Intel® 845MP/MZ Chipset Platform

Design Guide Update

November 2002

Order Number: 252180-001

Figure 8. THRMTRIP# Circuit Recommendation

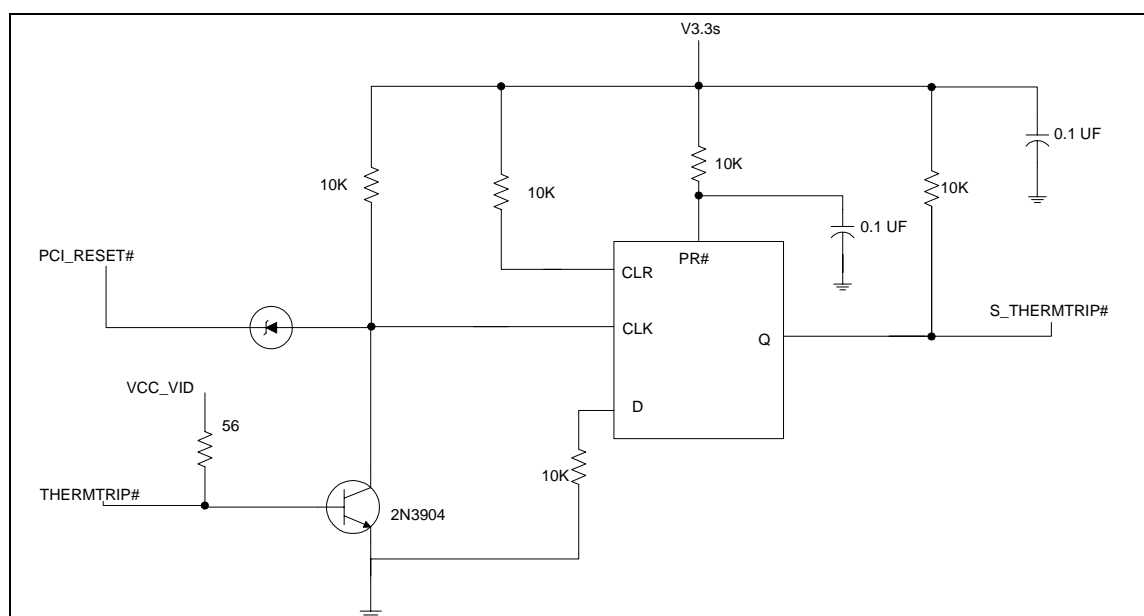
NO.	DOCUMENTATION CHANGES
1	Changed THERMTRIP# circuit design recommendation.

1. Replace section 3.4.4.1 with the following:

3.4.4.1. CPU THRMTRIP# Circuit Recommendation

The following sections describe the topologies and layout recommendations for the miscellaneous signals. In Figure 8, the circuit effectively latches the low state of THRMTRIP# via the D Flip-Flop once the processor has driven THRMTRIP# to a low state. Operation can be restored if the system power is cycled (power off/on system).
